IN THE
SUPREME COURT OF VIRGINIA

STATE BOARD OF HEALTH OF THE
COMMONWEALTH OF VIRGINIA, et al.,

AGENCY RECORD

APPENDIX II

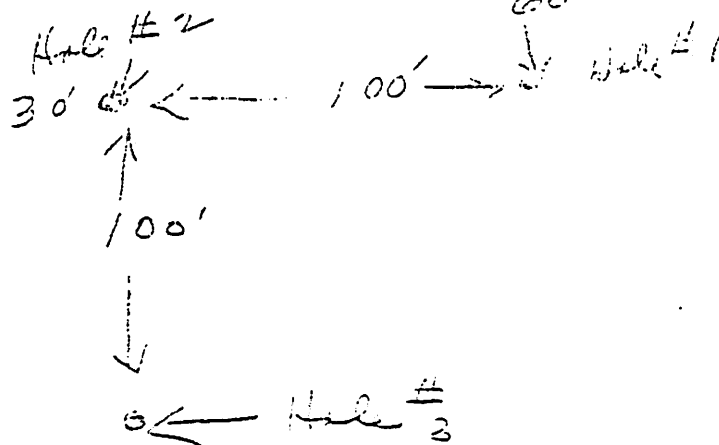
SOIL: This soil is very similar to area previously rejected as unsatisfactory.
0-3" Brown Silt Clay Loam
6-20" Yellowish Brown to Olive Brown plastic type clay.

20" + Weathered material with clay flows also brown and black concretion. This material extends to rock.

NOTE: Because of very slow absorption rate in plastic type clay of upper horizon, restriction of water flow due to clay particles in lower horizon and evidence of seasonal water table, we must reject this area for subsurface drainfield use.

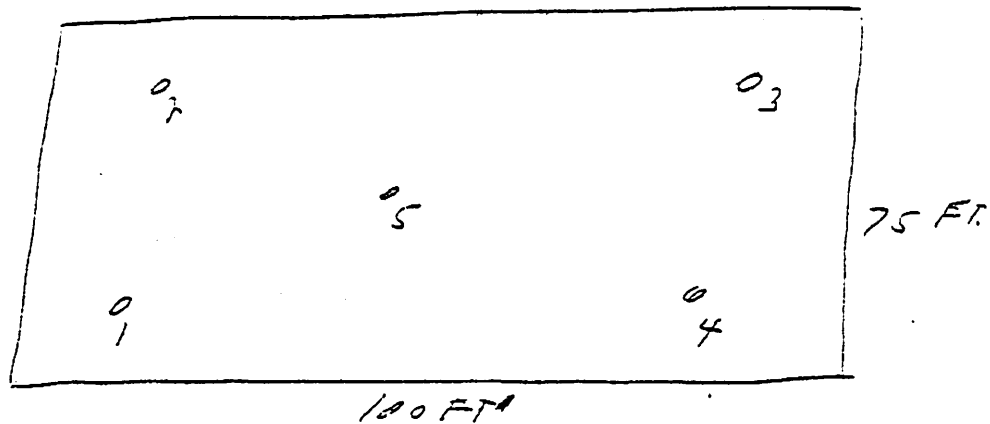
Site I (see attached plat plans)

Problems - variable depths to weathered materials, Plastic Clays & Seasonable water tables, Limited areas of Satisfactory Soil.

Site II

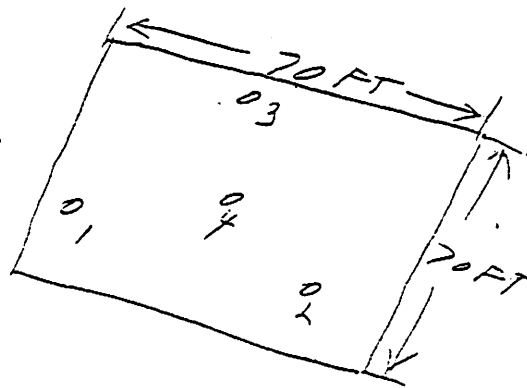
Majority of Soil is Plastic Clay
Weathered Rock is Deeper Than Site I But Water Was
Found In #2 Test Hole And All Signs Point To High
Seasonal Water Tables (Mottling In All Test Holes But one) In
Addition To Lack Of Soil Which Will Percolate Water
